**DEPARTMENT OF THE AIR FORCE
AIR FORCE CIVIL ENGINEER CENTER**

**SUBJECT: Final Revised Proposed Plan, Operable Unit 1, Site CG070, former George
Air Force Base (AFB), California**

This Final Revised Proposed Plan has been prepared in response to comments on the Draft Final Revised Proposed Plan from the RWQCB, Lahontan Region, and the U.S. EPA received on January 31, 2014 and February 4, 2014, respectively. See Response to Comments Table within the final document.

Revised Proposed Plan Operable Unit 1, Site CG070 Former George Air Force Base

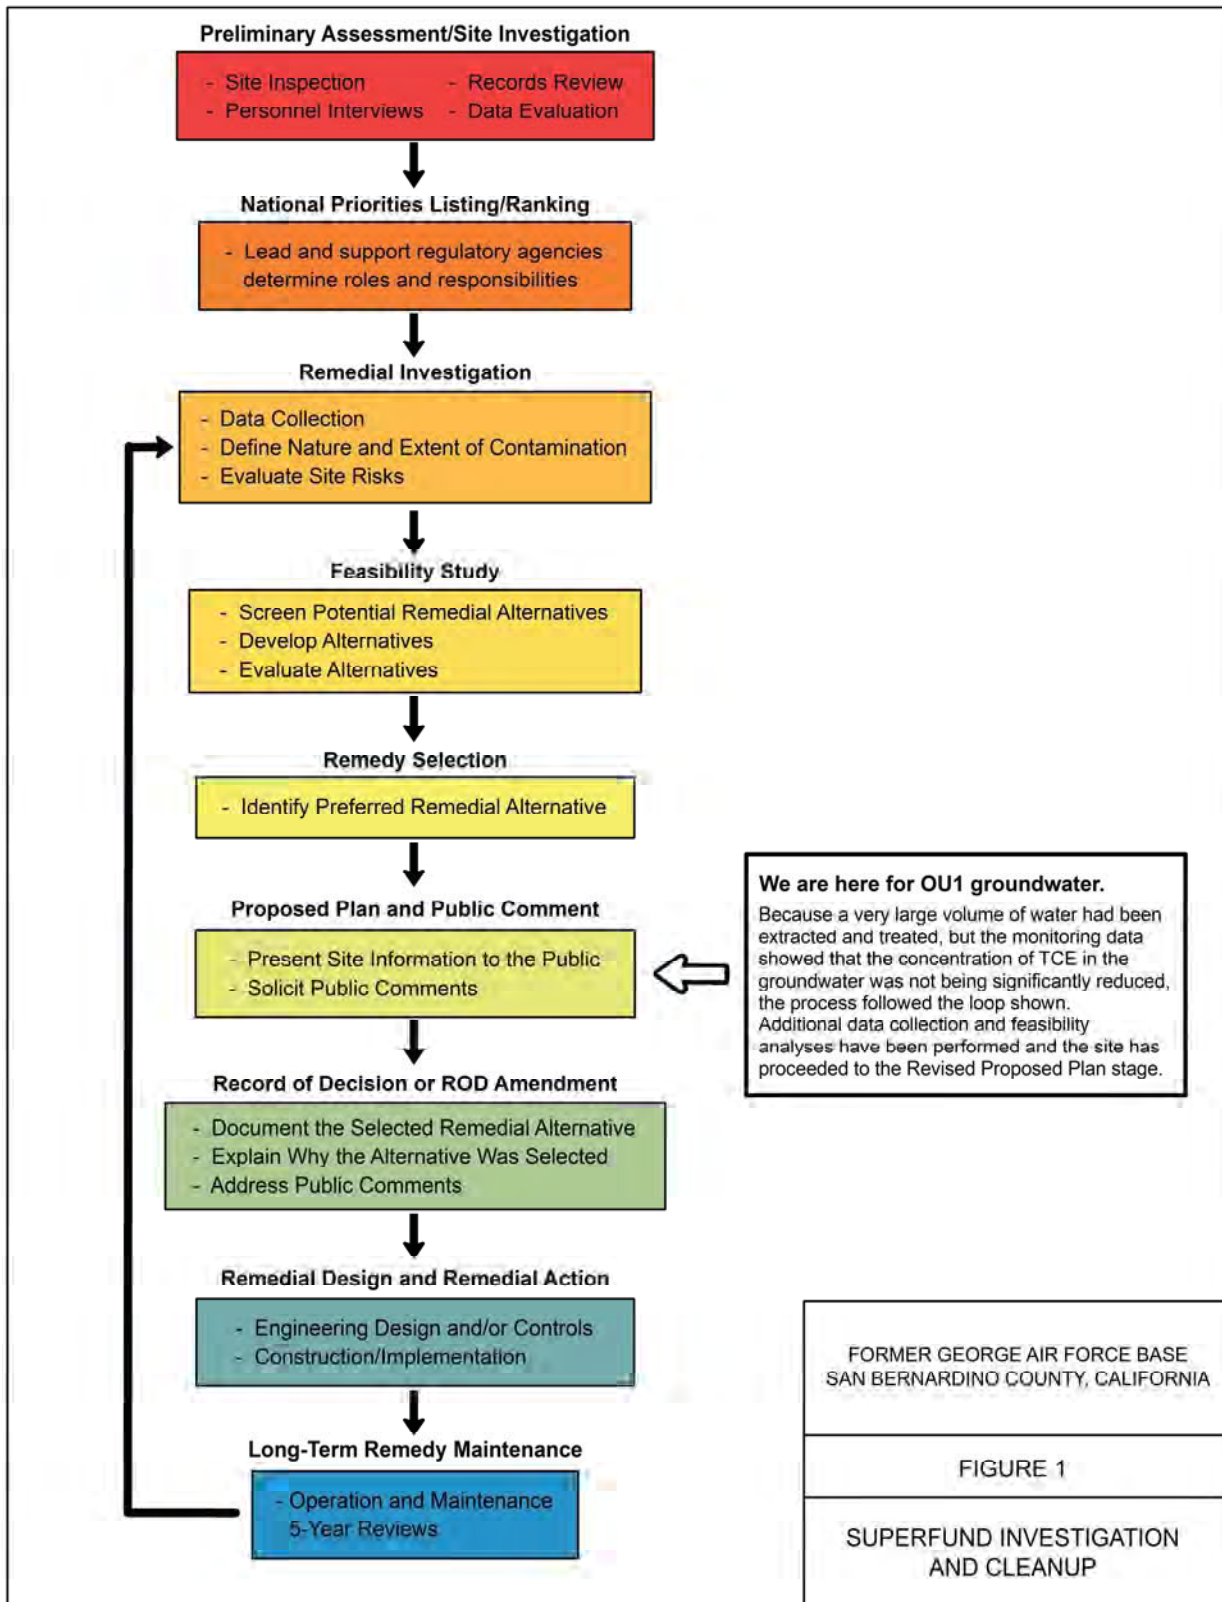
4.	4. Section A. Introduction, Figure 1,	It is unclear if this figure is intended to be a general description of the Superfund	Figure 1 is revised to address the comment.

Figure 2
George Air Force Base Location Map

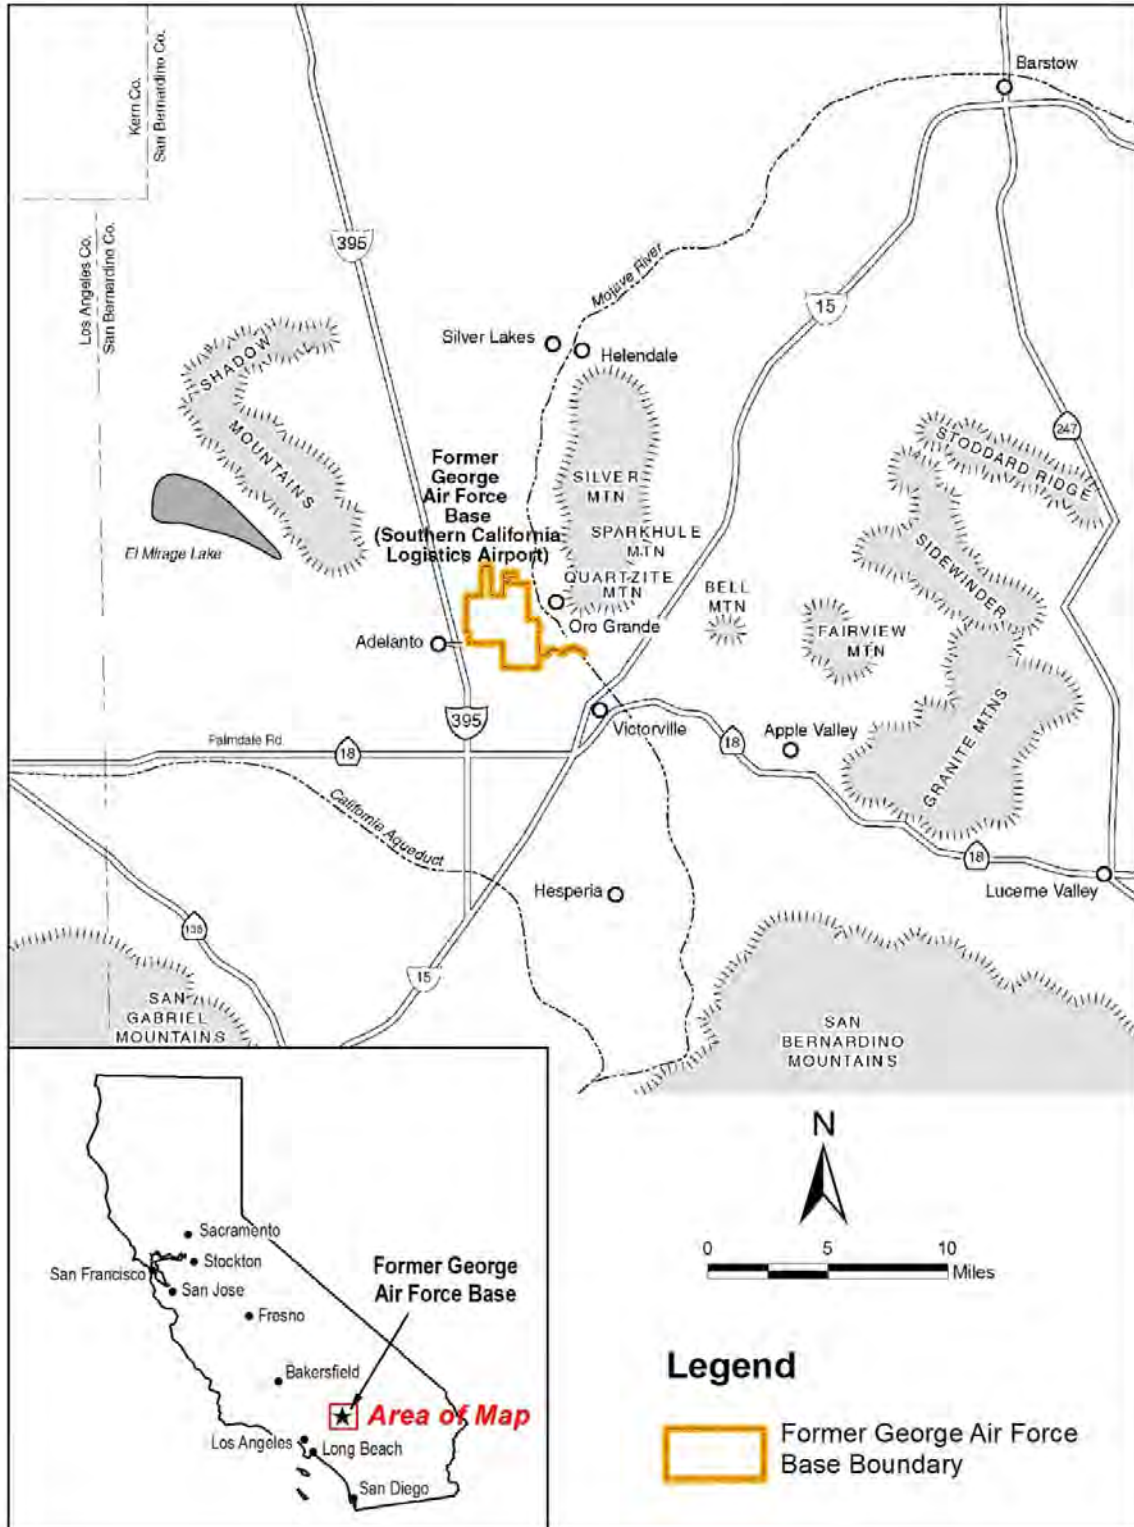
8.0	Site Background, page 4	Revise the first sentence to specify whether the "upper Mojave River Basin" is a watershed basin or a groundwater basin. Also this sentence includes a reference to Figure 2, but this figure does not show the basin. Reconcile this inconsistency.	Text is revised to: "GAFB is located in San Bernardino County, California, approximately 70 miles northeast of Los Angeles. The location of GAFB is shown on Figure 2."

Figure 3
Aerial Location of the OU1 Sites SD025, WP026, CG070, the Source Areas FT019 and FT082, and the Current Extent of OU1 Site CG070 TCE Plume

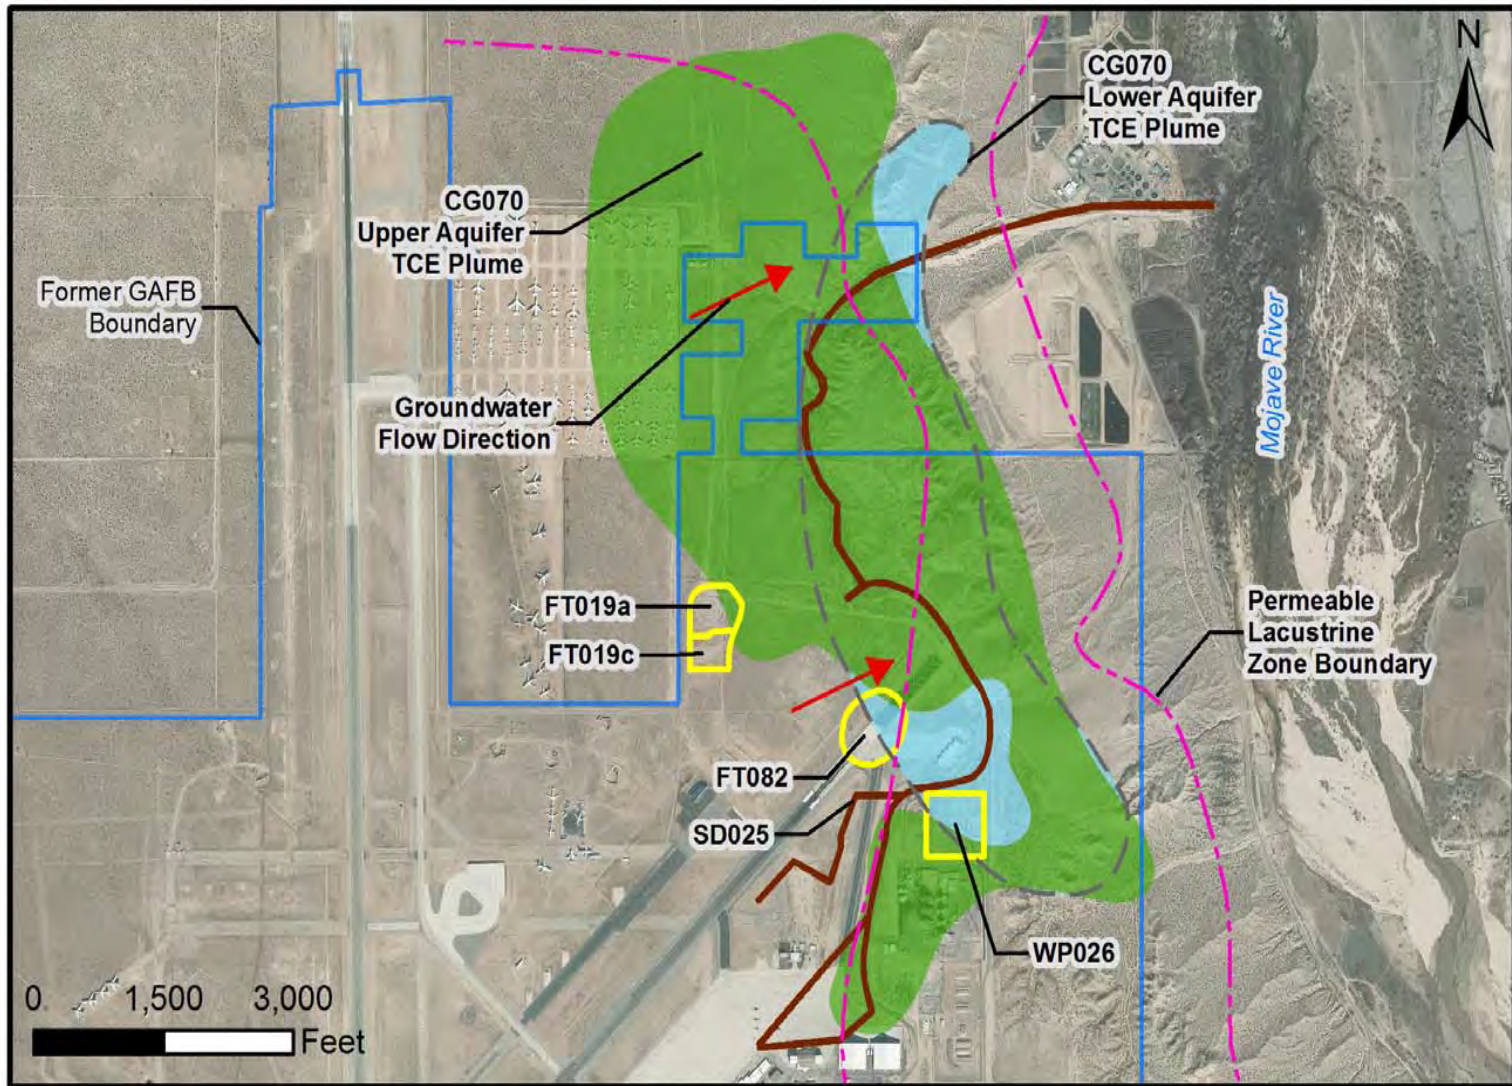
13.	Section C. Site Characteristics, Pages 7 through 9 and Figure 3	<p>Location of the three OU 1 Sites: There are a number of features discussed in this section that are relevant to understanding the conceptual site model and groundwater flow that are not presented in Figure 3, such as the "bluffs" and the Mojave River. Please revise Figure 3 to include the identification of key surface features.</p>	<p>Key surface features are depicted on the revised Figure 3.</p>

Figure 8
Base Hydrogeology

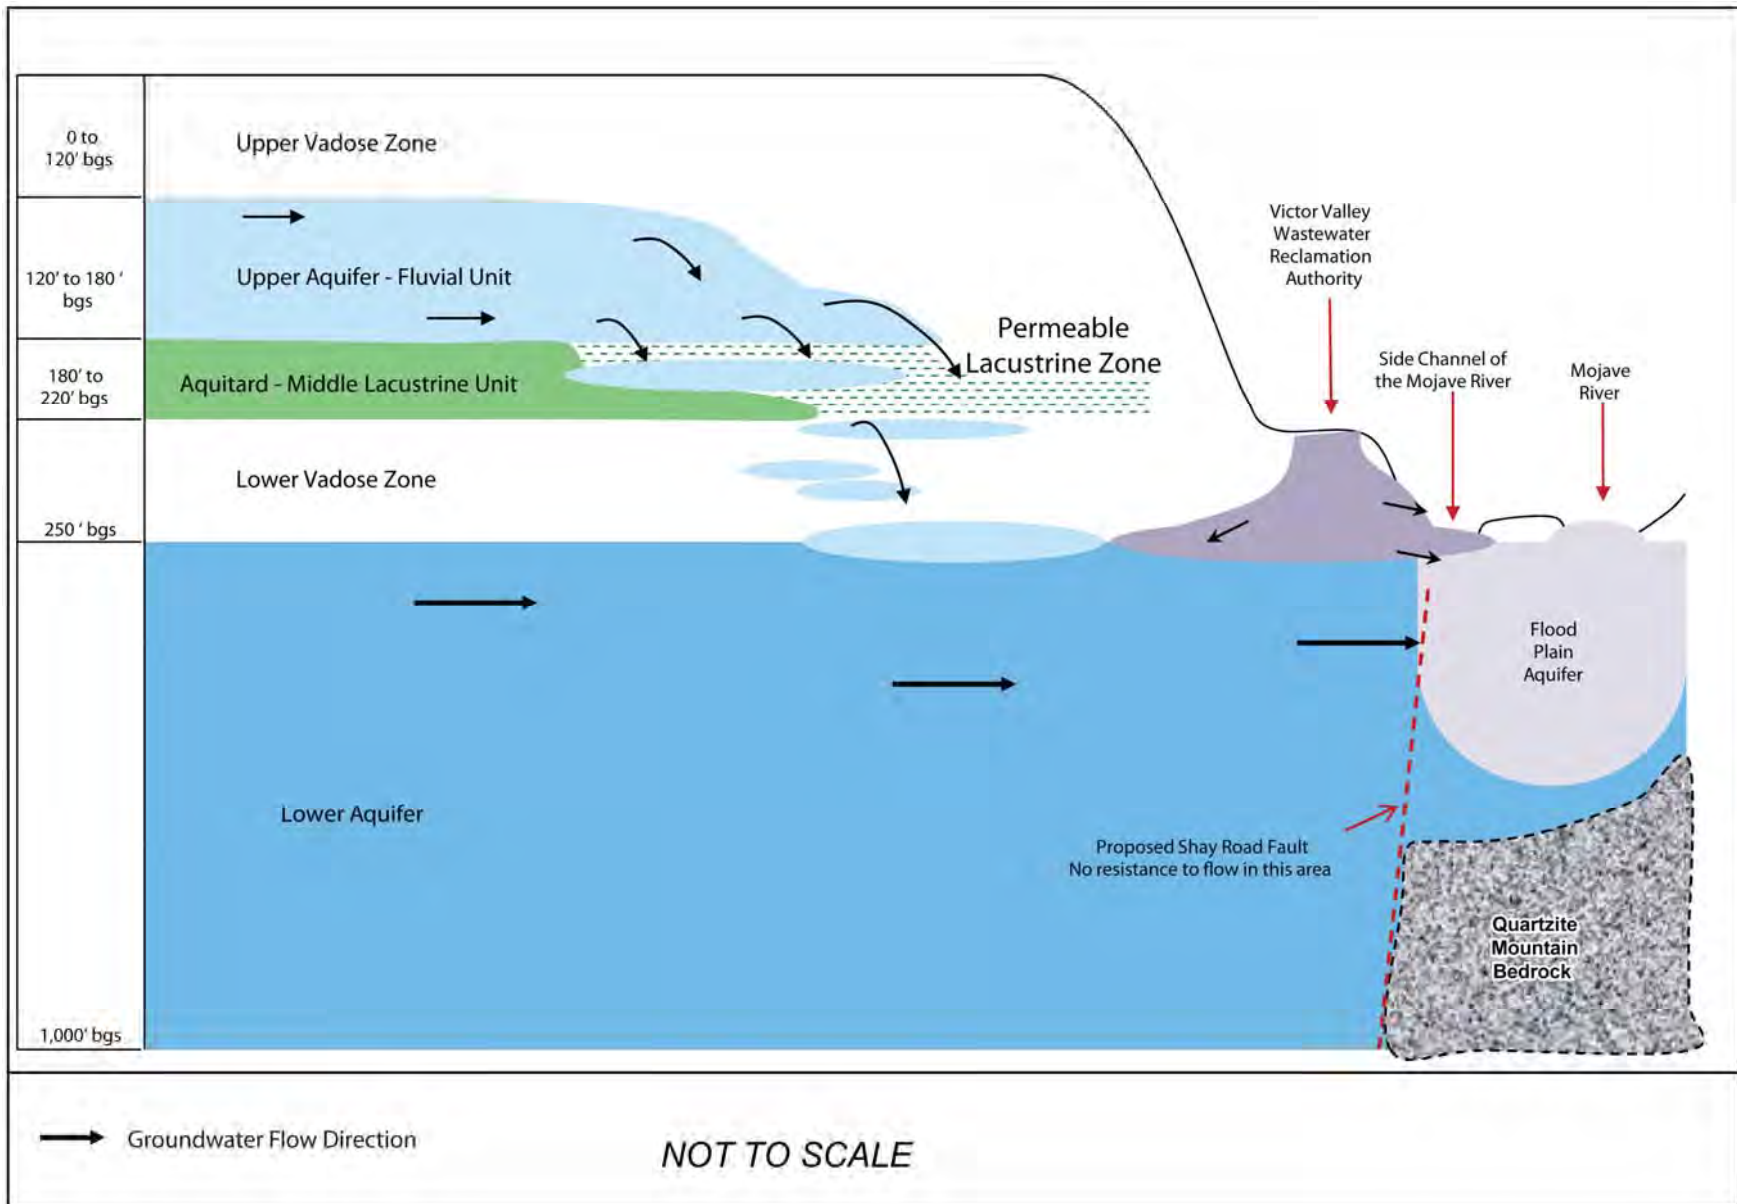
15.	Section C. Site	<p>This figure is important and contains</p>	<p>The figure is revised and the figure number has changed to Figure 8.</p>

Item	Section, Page	Comment	Response
	Characteristics, Figure 4. Base Geology, Page 8	useful information to support the text, but it is too small to read as currently presented. Please enlarge this figure to an entire page so it can be easily read and reviewed alongside the text at the same time.

Figure 11
Nitrate Plume Maps for Lower Aquifer

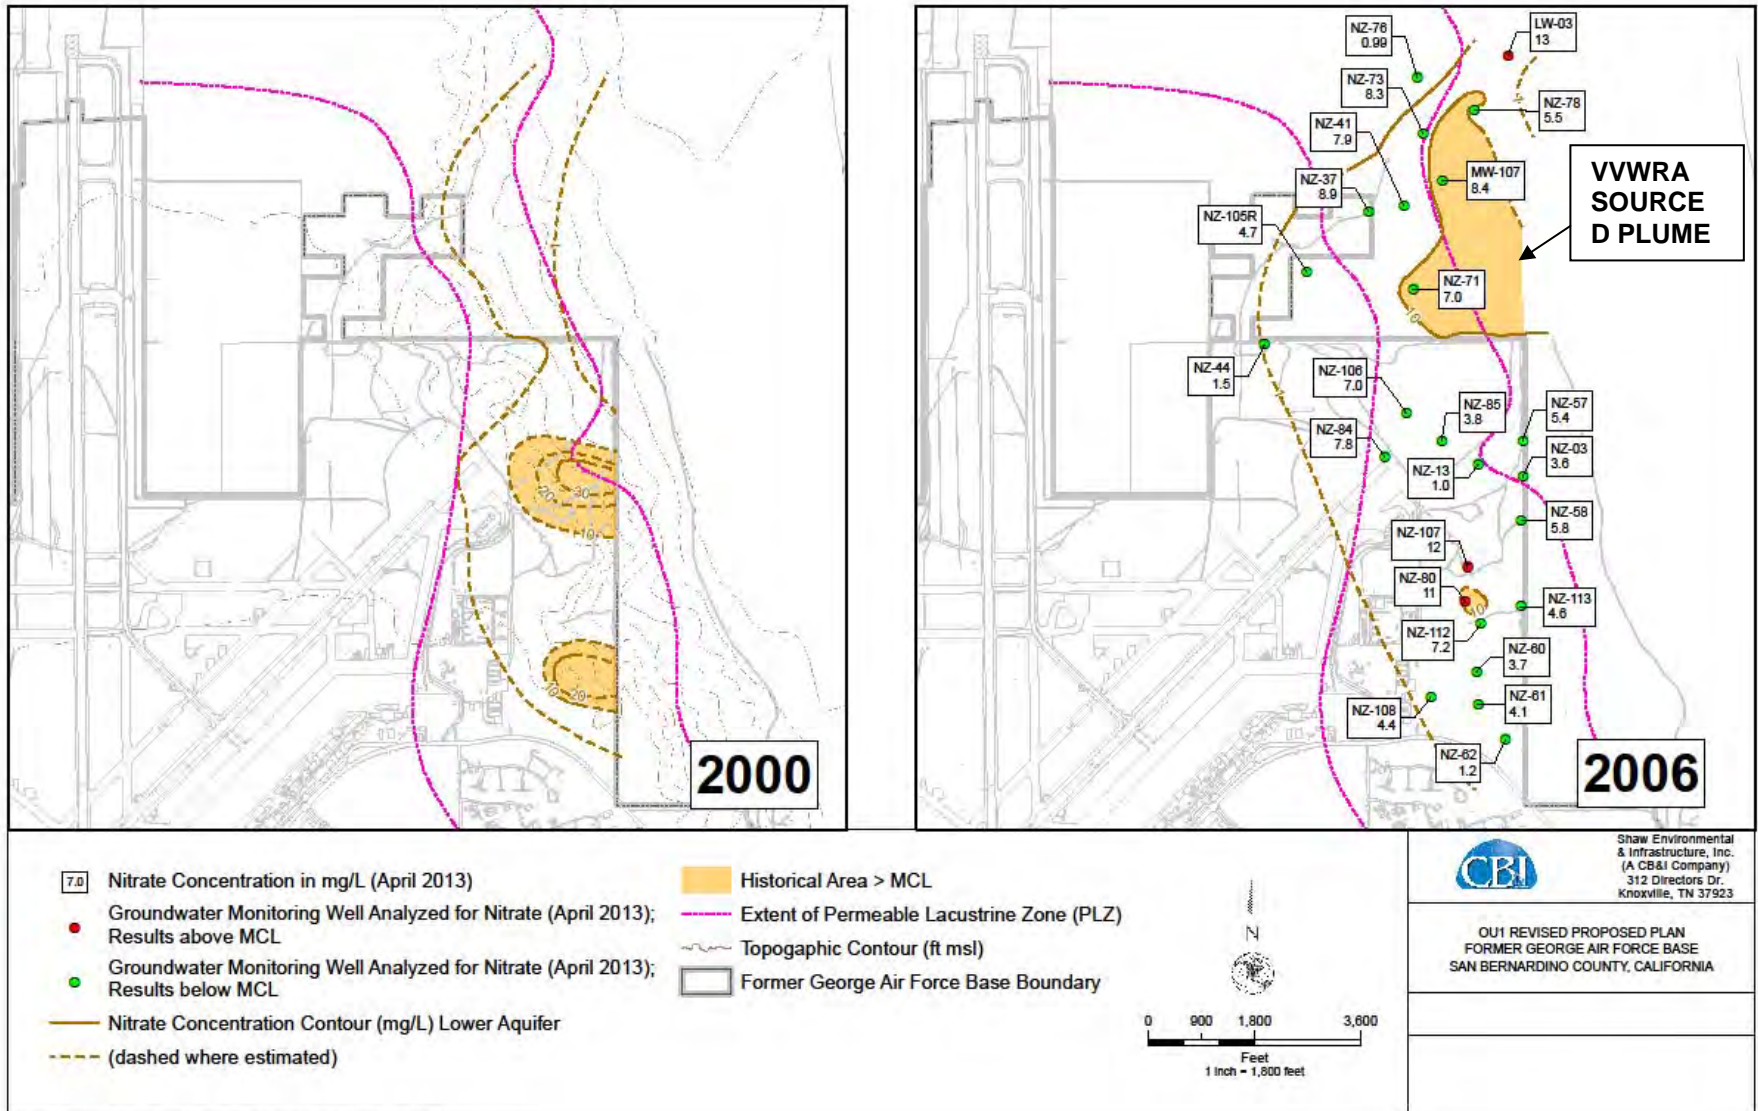
8	Section C, Site Characteristics	18	The seventh paragraph discusses nitrate plume reductions over time and refers to Figure 11; however, the eastern plume boundaries on Figure 11 are straight lines that truncate the plumes. Please clarify whether the stated reductions in plume volumes represent the total plume volume or whether they represent plume reductions within base boundaries.	The 2000 plumes are constrained by the base boundary. However, the recent data show that the plume is limited to a few wells that are surrounded by wells with concentrations below the MCL. The remnants of the plume are restricted to the base property.
9	Figure 9, TCE Plume Boundary Map – Not to Exceed 5 ug/L	20	In the printed form, this figure is not readable, especially the cross-sectional diagram below the main figure. Further, there are no landmarks to identify plume boundaries. Please remove the cross-section and present it as its own figure and include street names or landmarks.	The two portions of the Figure are now included as Figures 9a and 9b. The primary landmarks visible in the map area are the airport runway and the Mojave River.

10	Figure 11, Nitrate Plume Map for Lower Aquifer	22	It appears that nitrate plume boundaries on the eastern side of this figure are either missing or in a perfectly straight line. Please include the nitrate concentrations above MCLs on the eastern side of the base boundary on this figure, or explain why it is not necessary to present the full extent of the plumes.	See comment 8 above
